**Re: SMUD Cogeneration Pipeline Project – Docket No. 92-AFC-2P  
Petition for Post Certification Project Modification  
Natural Gas Pipeline Relocation in Yolo County**

| SMUD Cogeneration Pipeline | ) | SMUD'S PETITION TO AMEND FOR |

# **Petition for Post Certification Project Modification**

**Figure 2**  
**Natural Gas Pipeline Relocation**  
**in Yolo County**  
**Proposed Alignment**

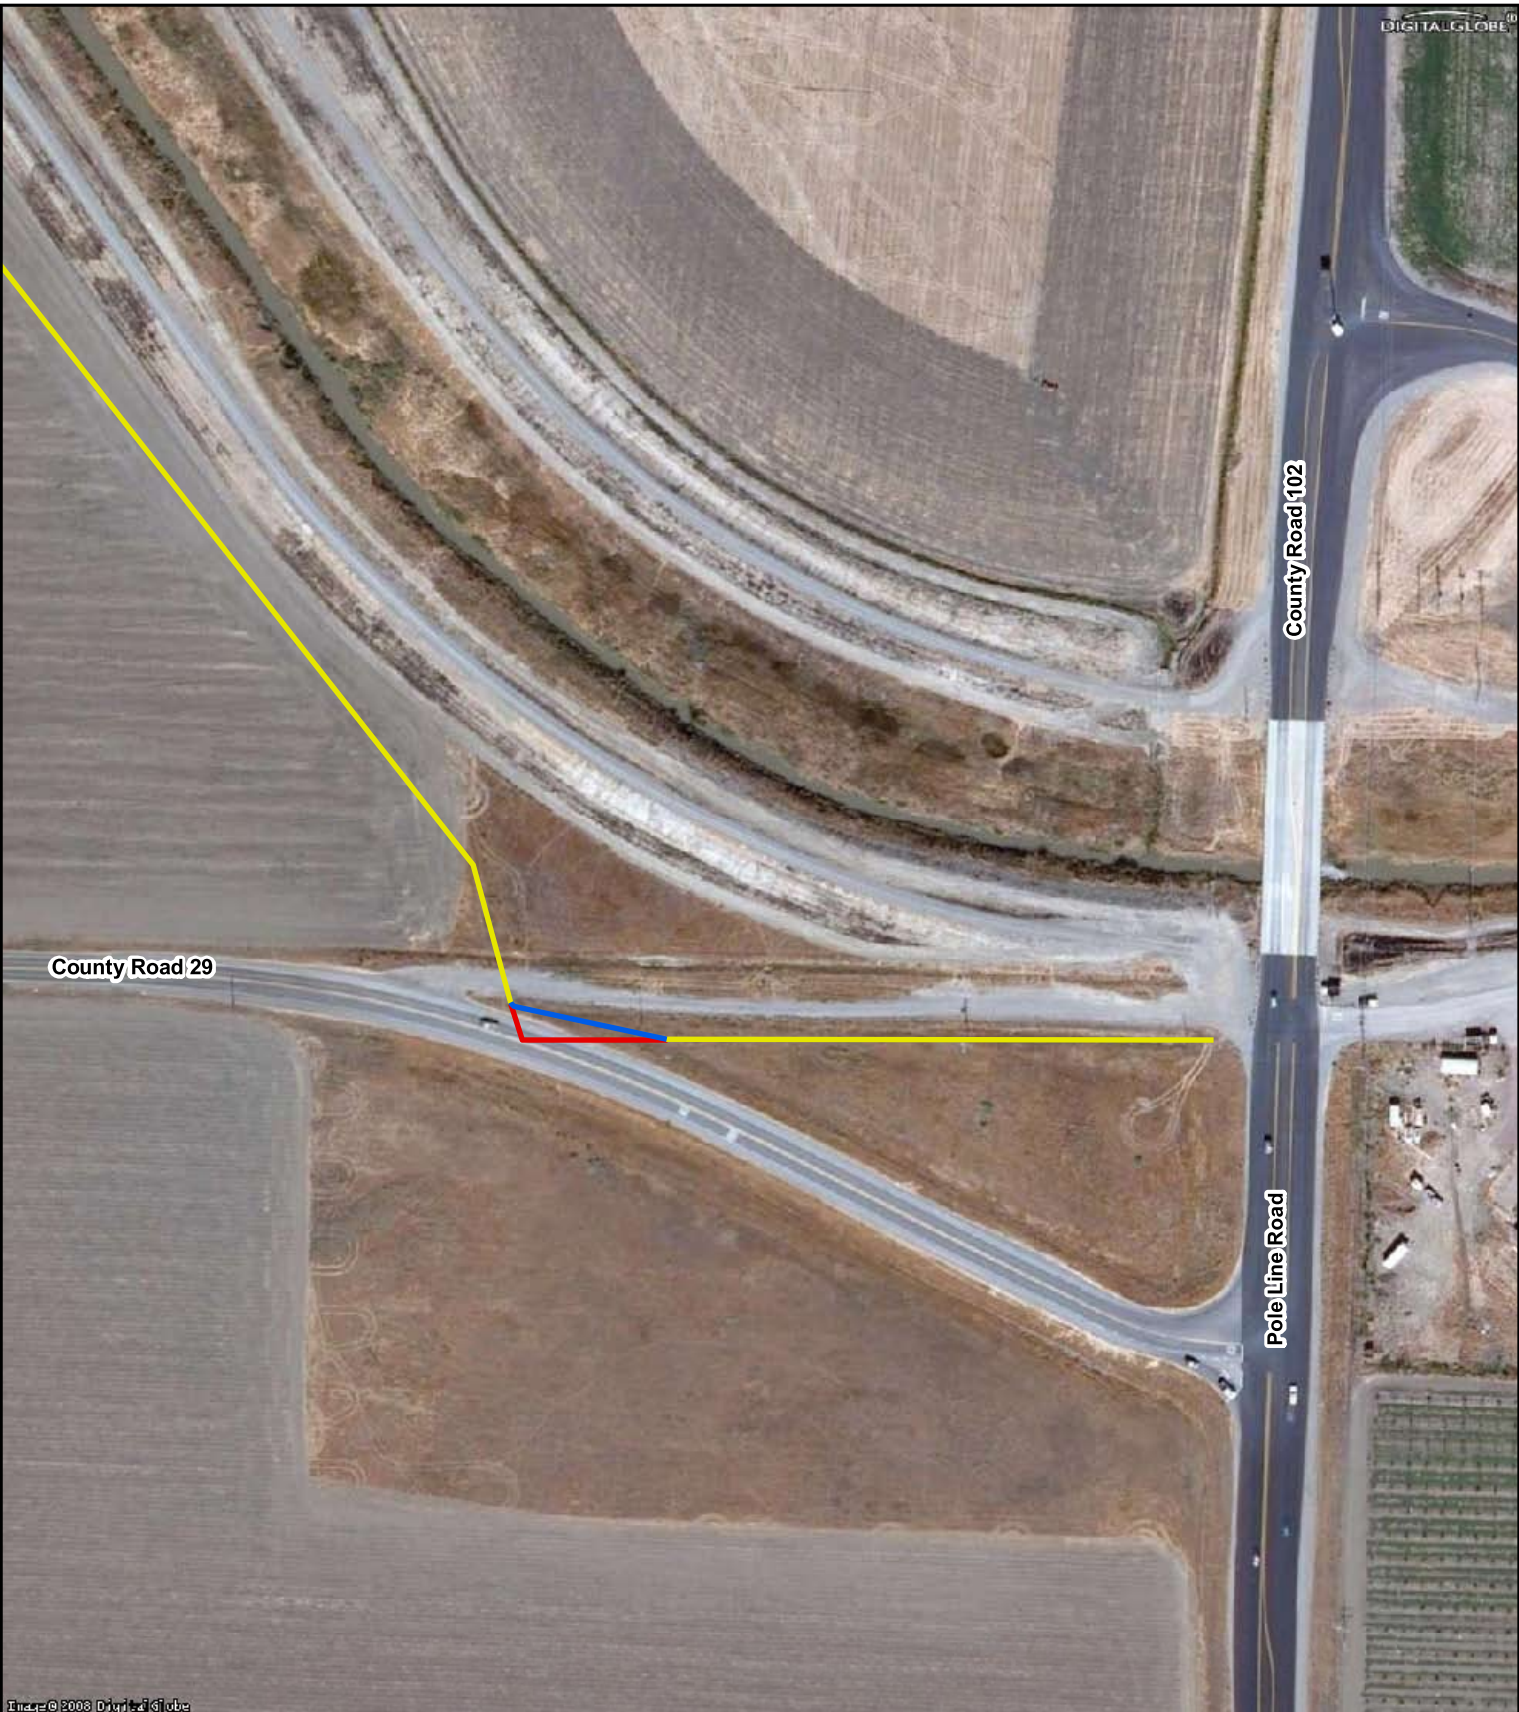
Line 700A will be relocated from existing pipeline Station 790+00 to approximately Station 791+50. Figure 1 shows the project location and the regional setting for the pipeline. Figure 2 shows the locations of both the existing and the proposed gas pipeline alignments.

The proposed relocation would begin just south of abandoned CR 29, turn southeast and parallel CR 29 for 150 feet, and then connect back into the existing pipeline, thereby avoiding encroachment under CR 29 (See Figure 3).
